ADDENDUM NO. 2

Three Rivers Community Schools – New Transportation Facility
58420 Haines Road
Three Rivers, MI 49093

A/E Project 5-5138

ADDENDUM 002

C2.01

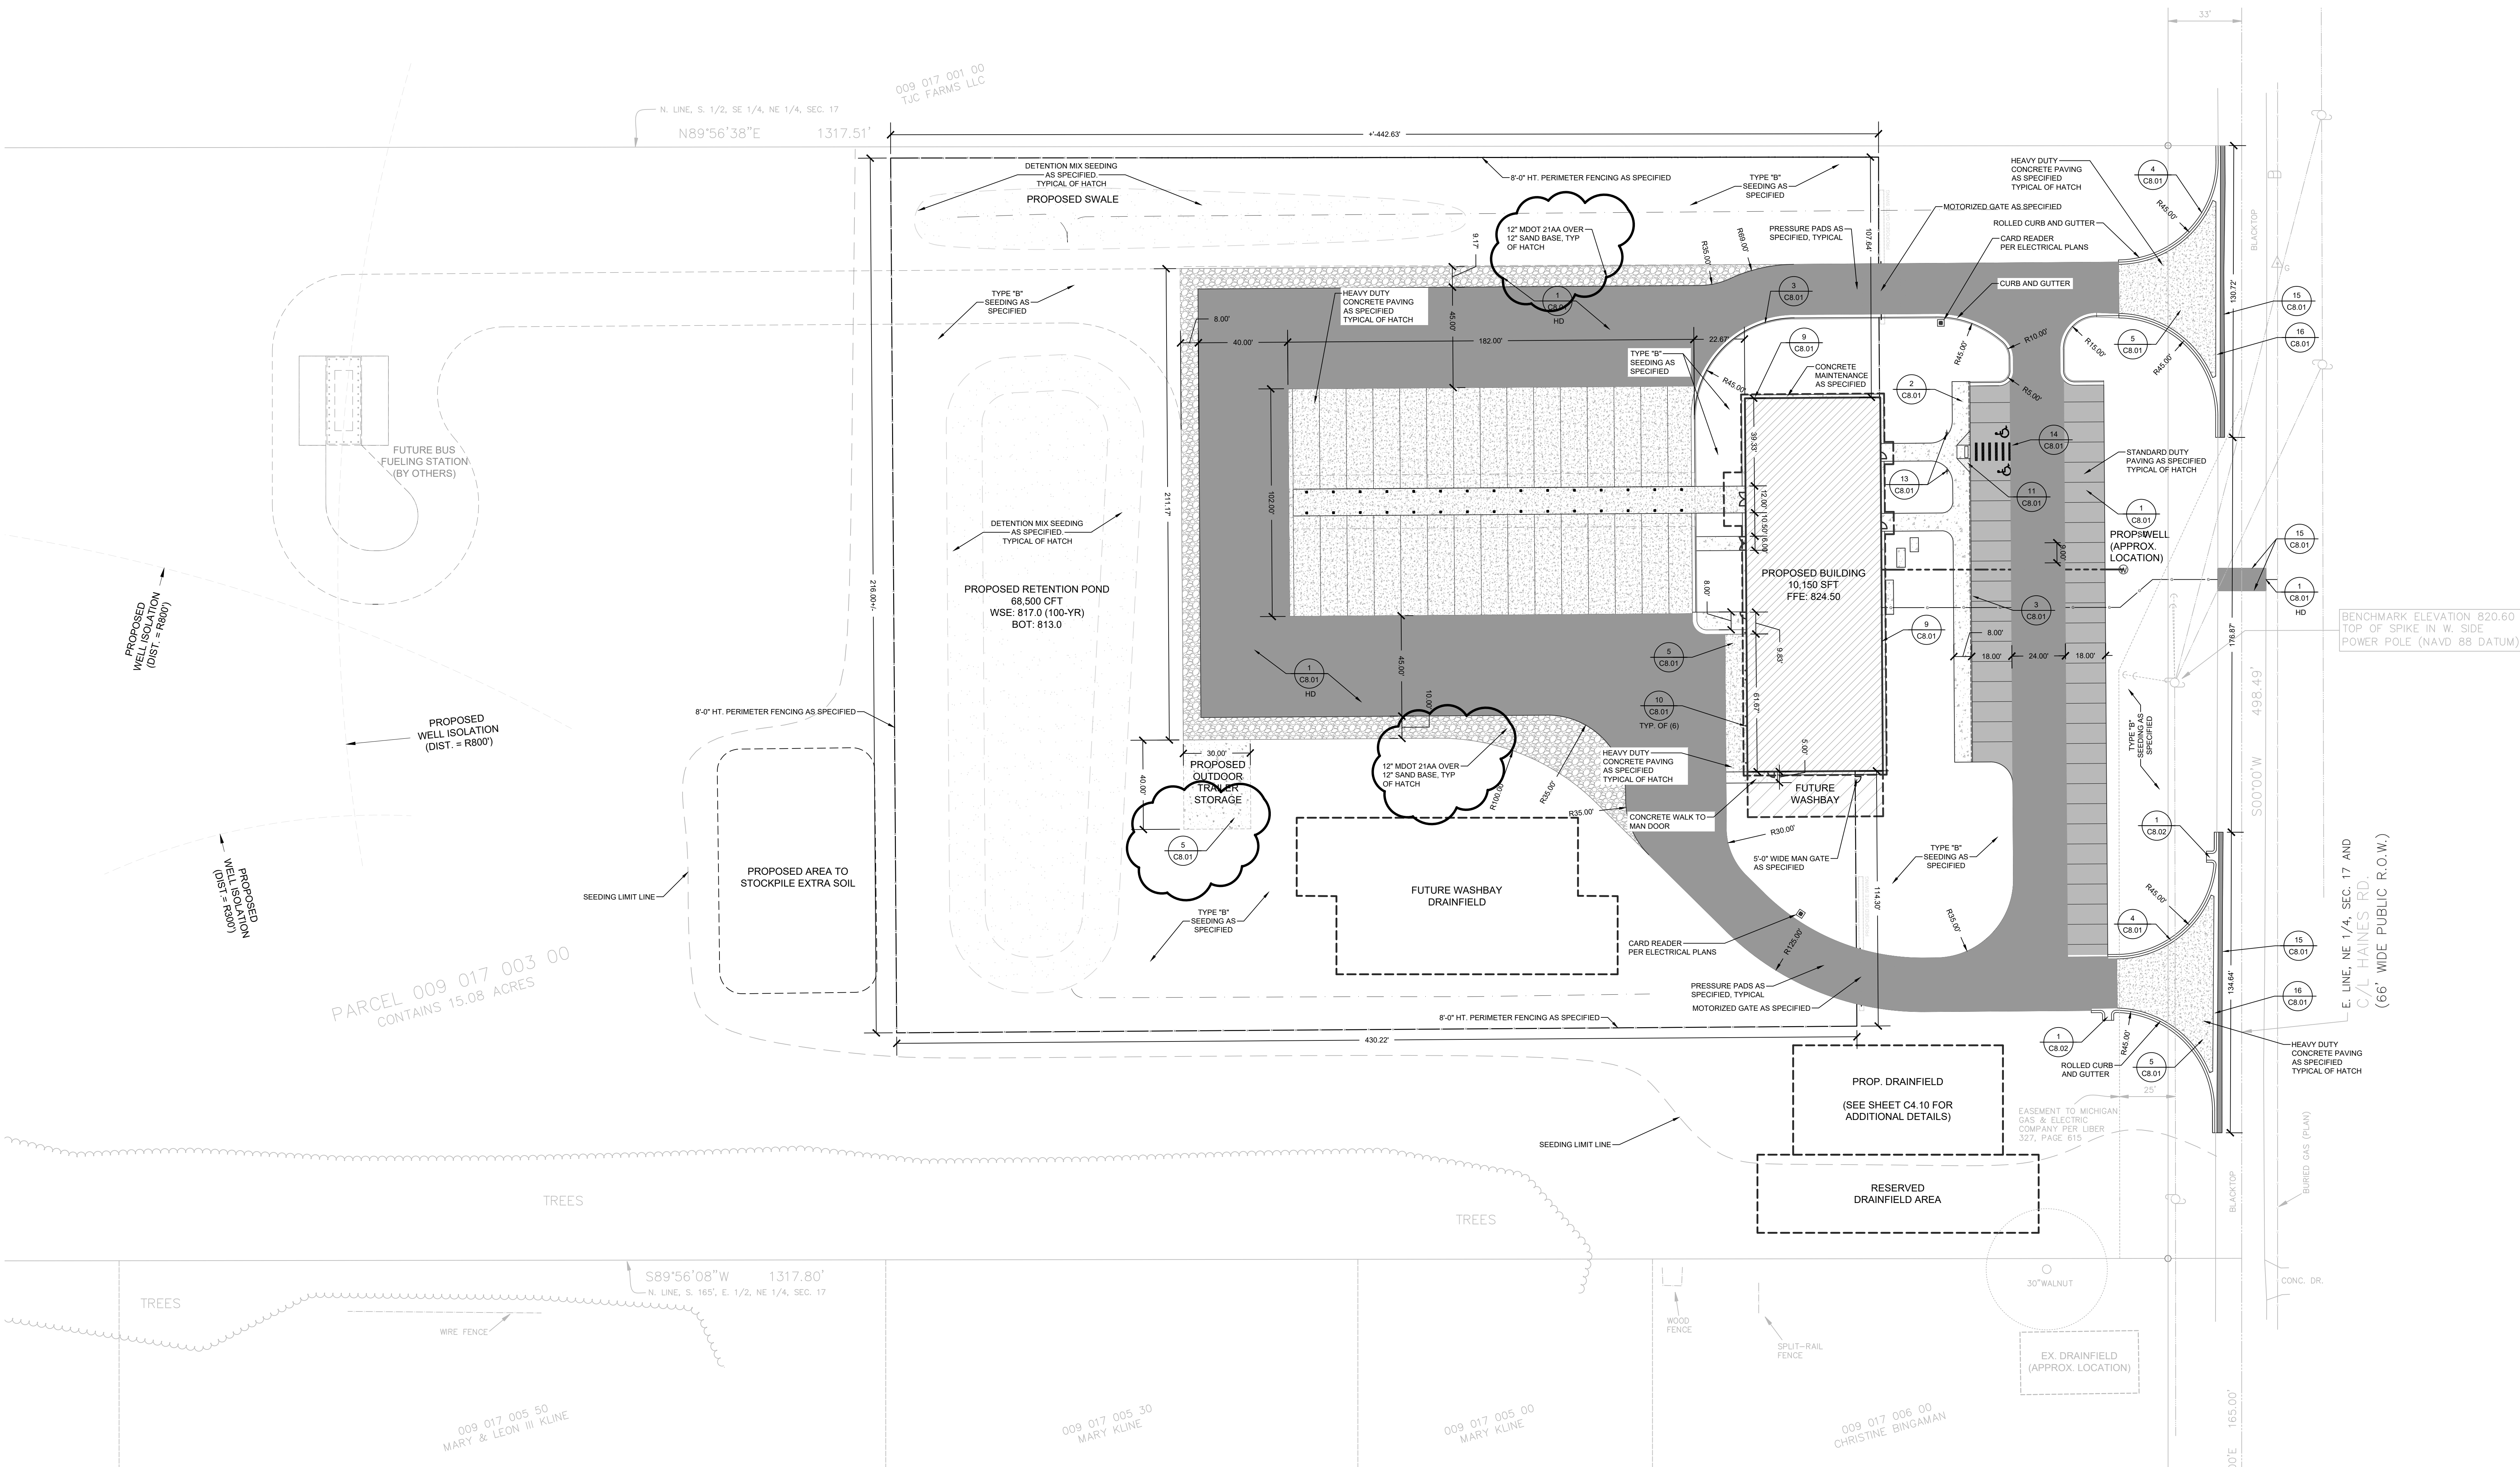
Bid Category No. 1 – Sitework is to include removal of all spoils from site. Location identified on C2.01 as “Proposed Area to Stockpile Extra Soil” is intended as communication and potential of temporary storage location for coordination only. All Spoils are to be removed from site.

Bid Category No. 1 - Sitework and **Bid Category No. 3 – Concrete** Contractors shall exclude any work associated with the “Proposed Outdoor Trailer Storage” Pad as shown on sheet C2.01. This is not part of the project scope.

6	Lounsbury	11/18/2022	11/22/2022	Sheet C 2.01 Site Layout shows aggregate around the north, west and south of the asphalt perimeter. What material should this be? And what is the cross section of this material?	Updated Per Addendum No. 2
7	TSC	11/18/2022	11/22/2022	Detail 2/C4.10 shows section through drain field and identifies Clean Coarse 2NS sand fill no compaction required. What is the dimension of this fill?	3 Feet
8	Lounsbury	11/18/2022	11/22/2022	Sheet C 4.01 Utility Plan sheet shows sanitary and then in the plumbing drawing show the connection and material to the building. Can you clarify where plumbing contractor stops and site work pick up sanitary work	Please see Clarifications as issued in Addendum No. 2
9	Crips Fontaine	11/22/2022	11/22/2022	The fencing spec calls for barbed wire on the new gates. Its does not clearly state if barbed wire is supposed to be installed above all the remaining fence. Does the new fence get barbed wire on it also?	Please see Clarification as issued in Addendum No. 2

ITEM NO. 4 SHEET C2.01 – SITE PLAN (REISSUED)

Added notation for gravel.

UTILITY PLAN

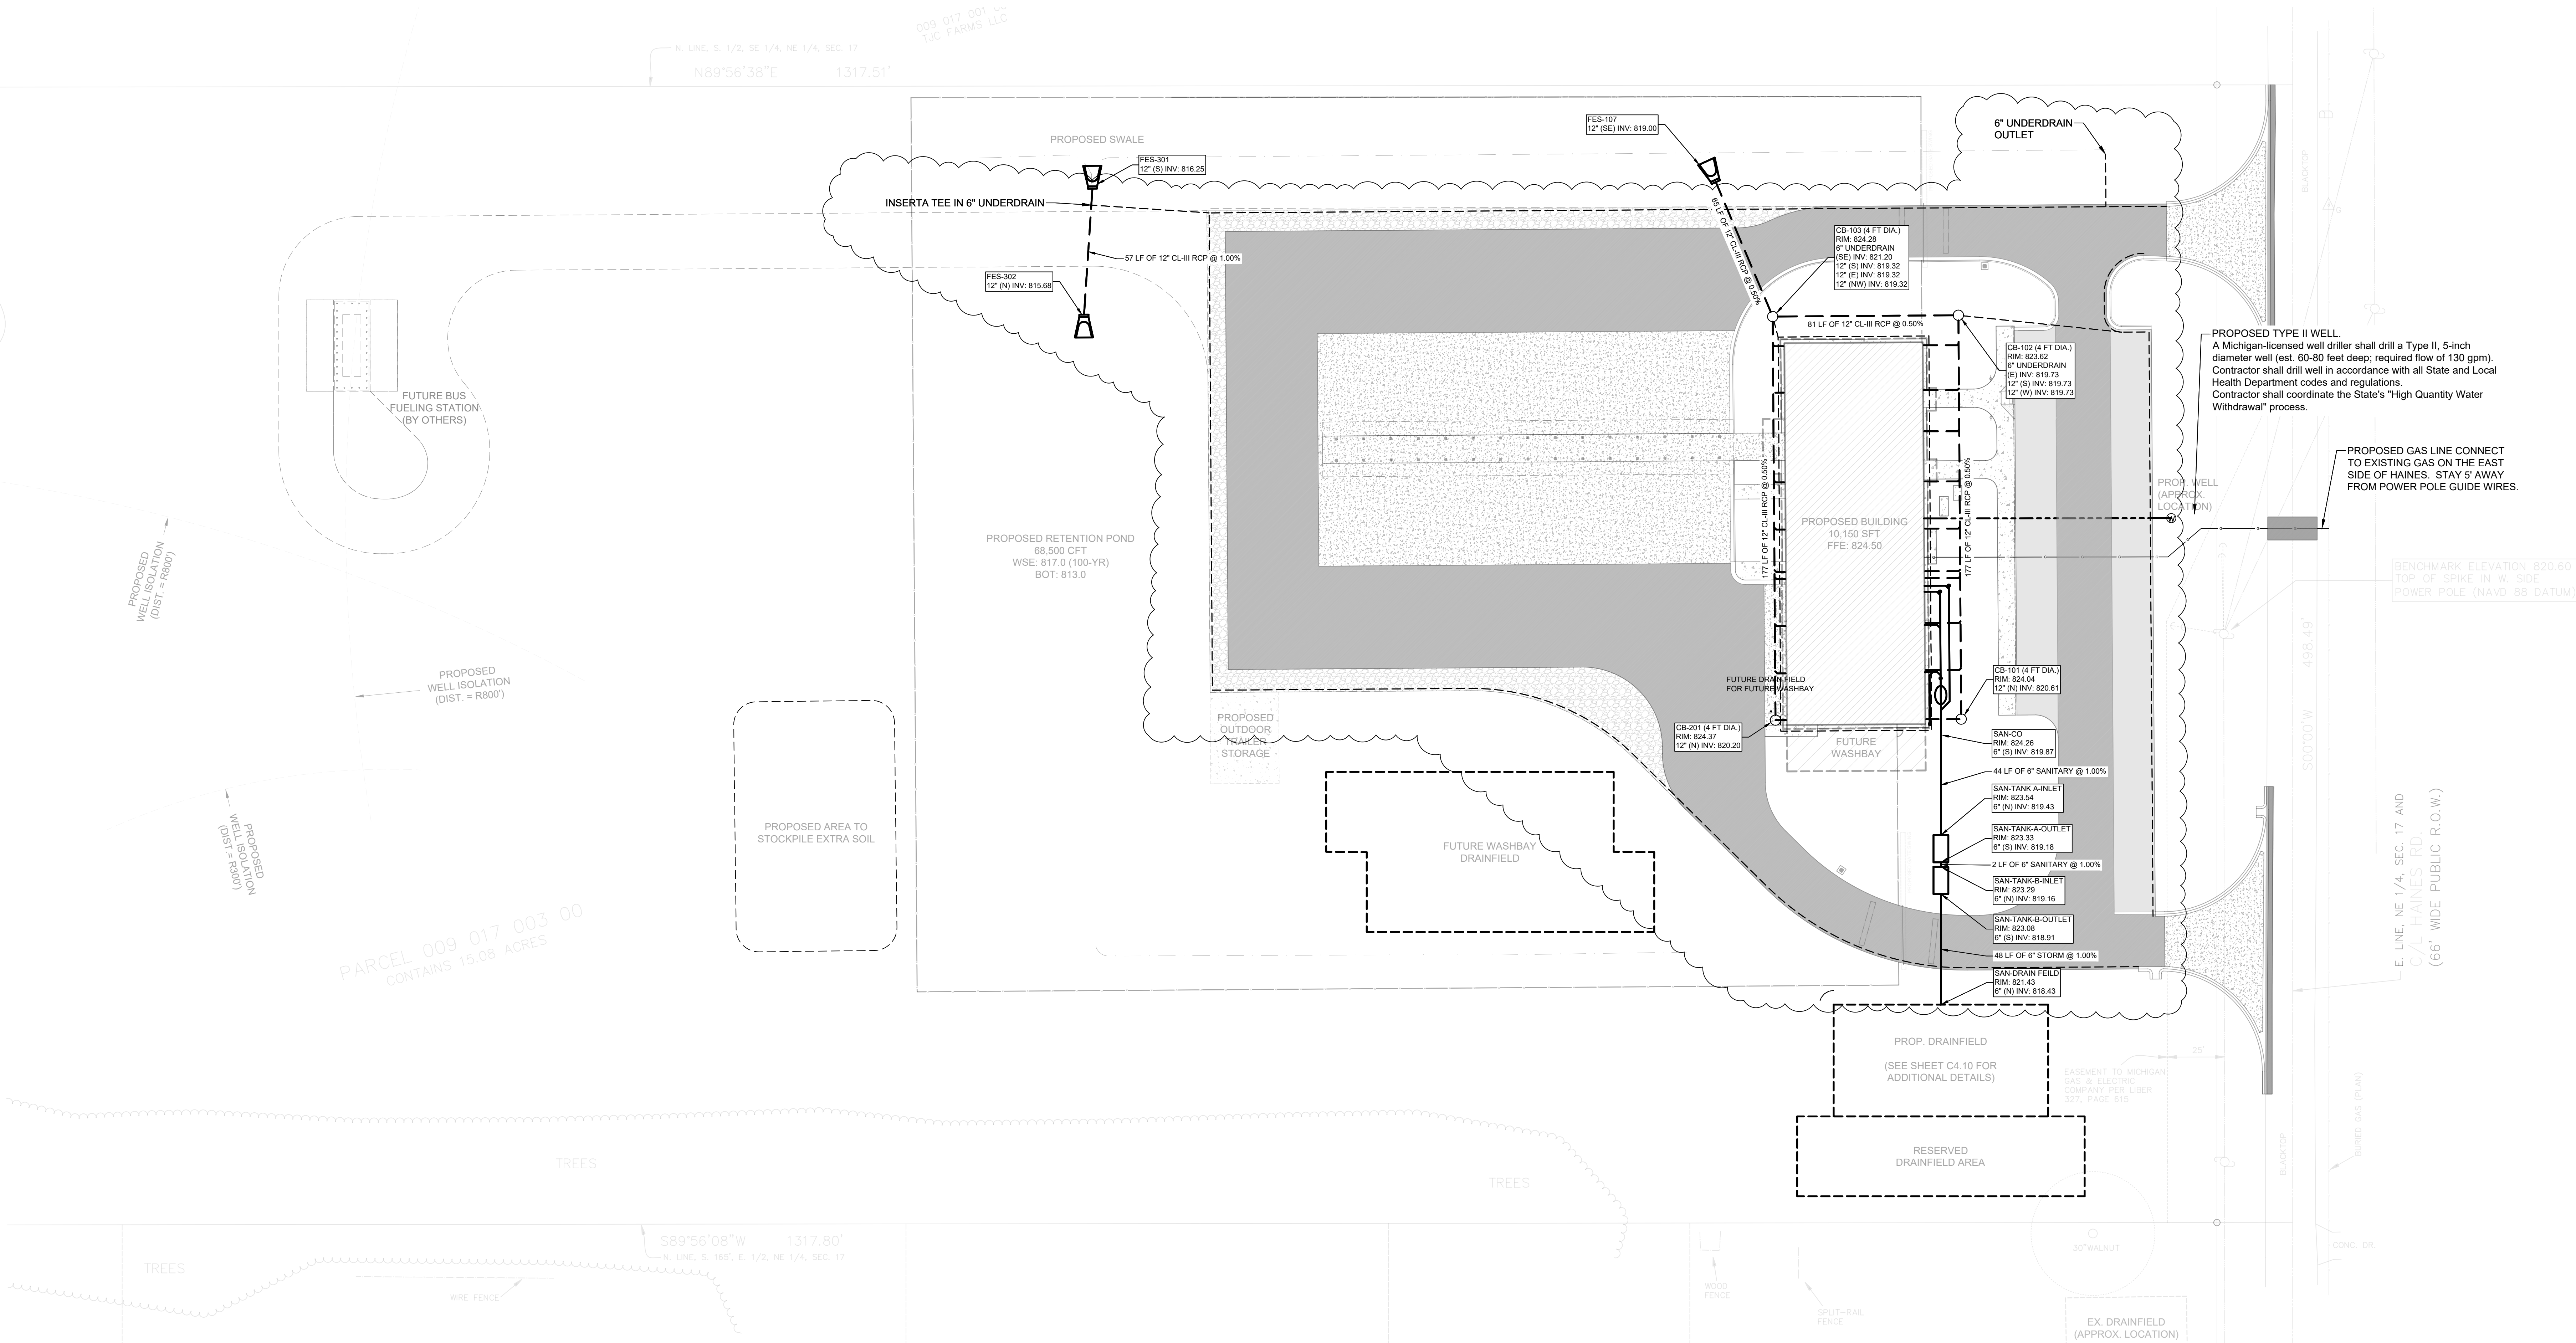
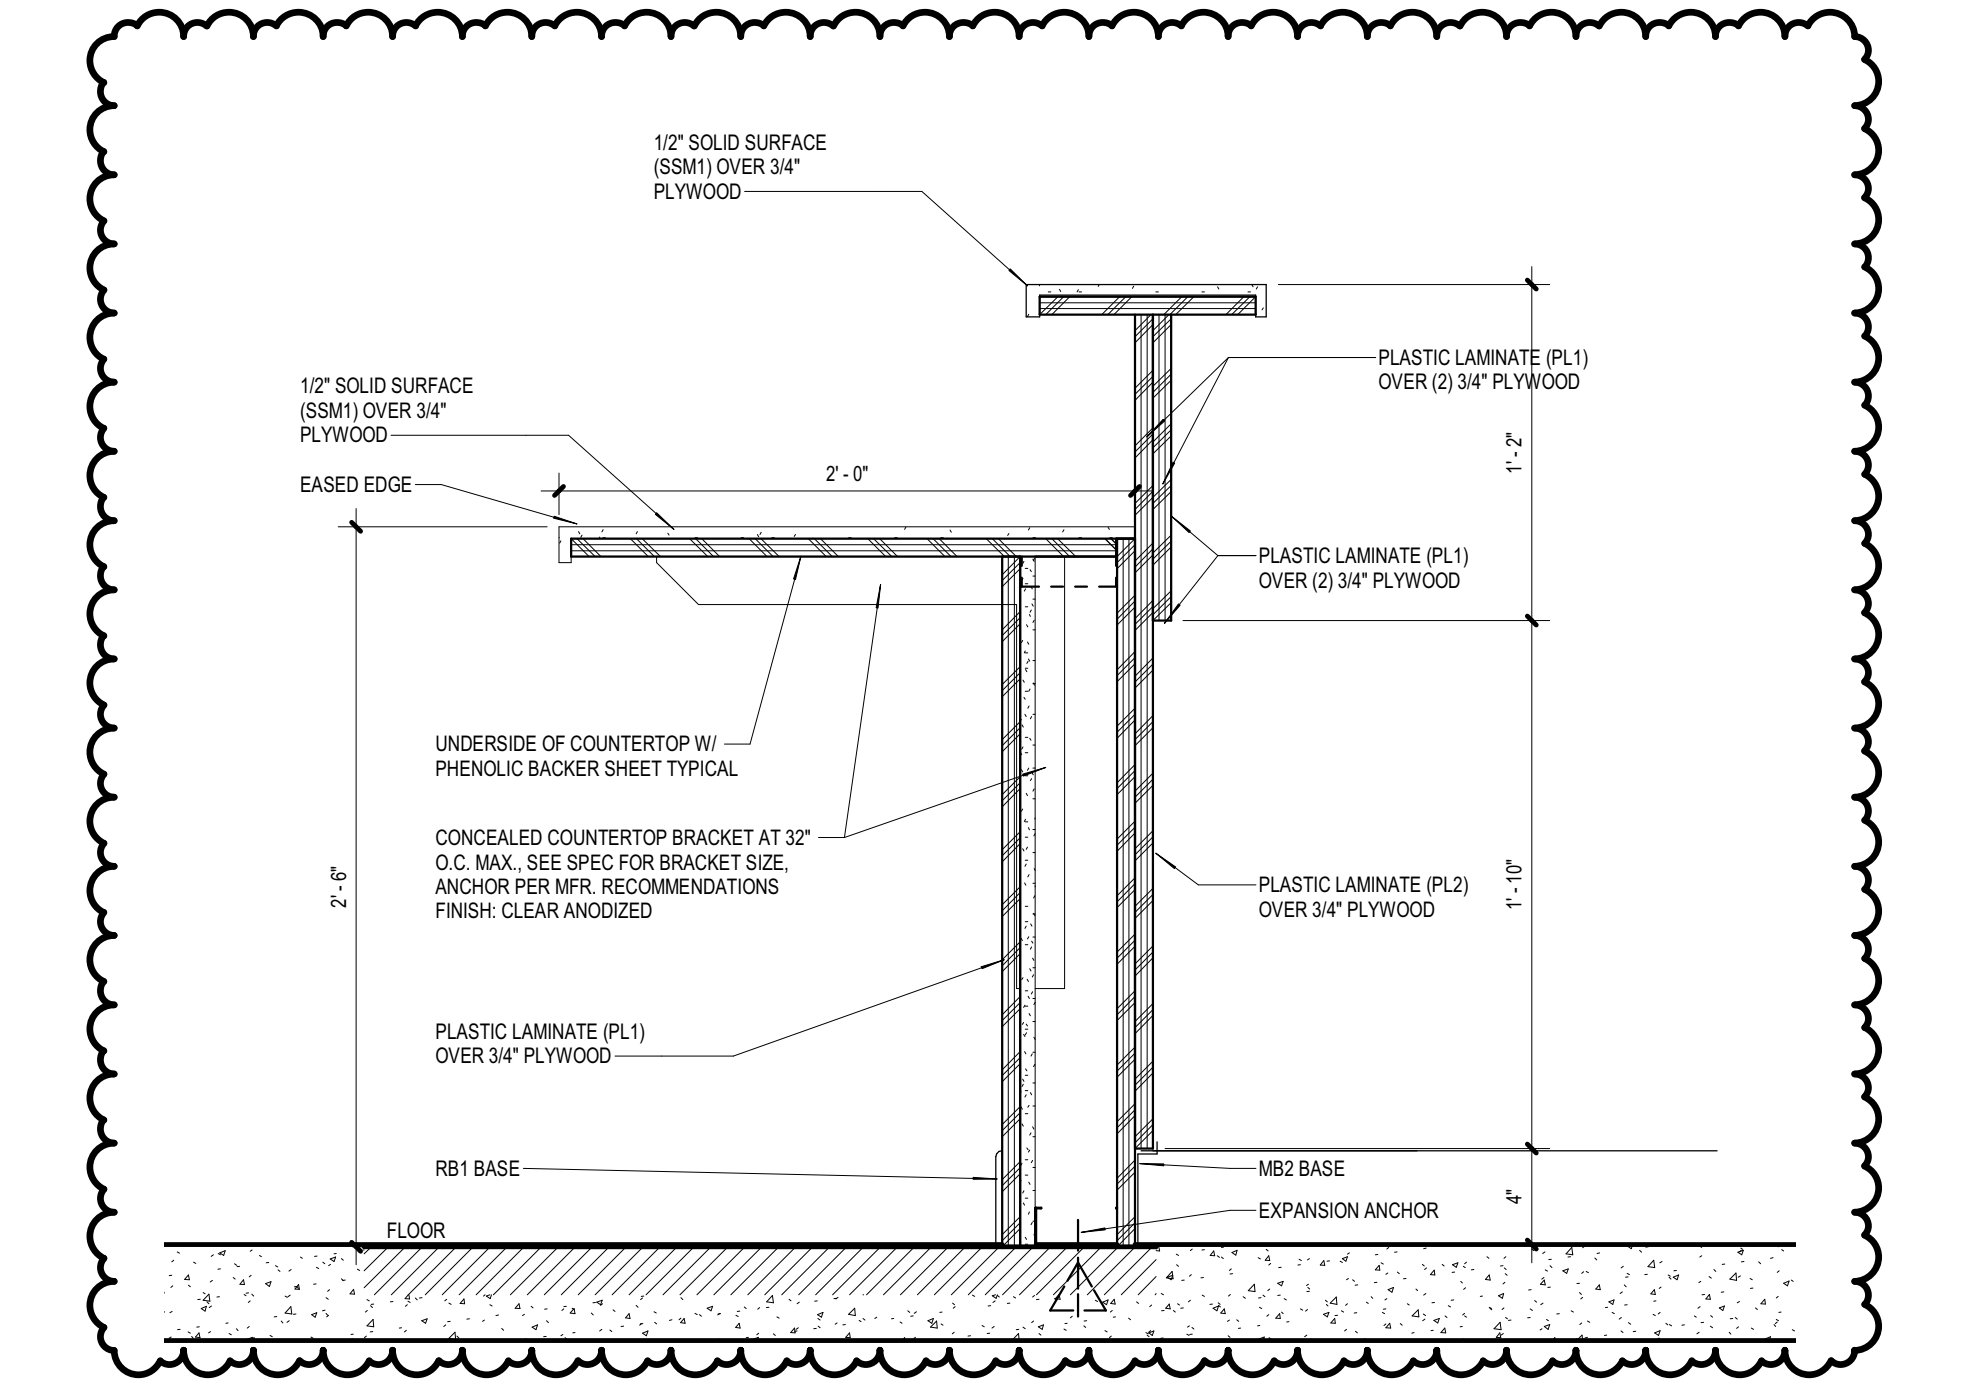
10	Crips Fontaine	11/22/2022	11/22/2022	Sheet C4.01 does not indicate the size of pipe required for the downspout connections. The details references plans for size of pipe. What is the actual pipe diameter of the downspout laterals?	Downspouts are 4"X4" use 6" PVC Pipe
11	Crips Fontaine	11/22/2022	11/22/2022	Section 33 31 00 references the septic tank size to be 2000 Gallon. It also calls out a 1000 Gallon dosing tank. The drawings do not indicate a dosing tank. There is an oval drawn near the building on the utility plan which I assume is another tank of some sort. Please clarify what this tank is. If a dosing tank is required for this project, we also need pump information.	The second is a dosing tank. The dosing tank is gravity flowed no pump is required
12	Crips Fontaine	11/22/2022	11/22/2022	There is an area shown on sheet C2.01 that is called the "proposed area to stockpile additional soil". Is the intent to stockpile ALL the additional soil from this project and leave it onsite as base bid? Or is that to be utilized as a temporary stockpile until we haul it offsite?	Please see Clarification as issued in Addendum No. 2

ITEM NO. 5 SHEET C4.01 – UTILITY PLAN (REISSUED)

Added 6" underdrain around gravel.
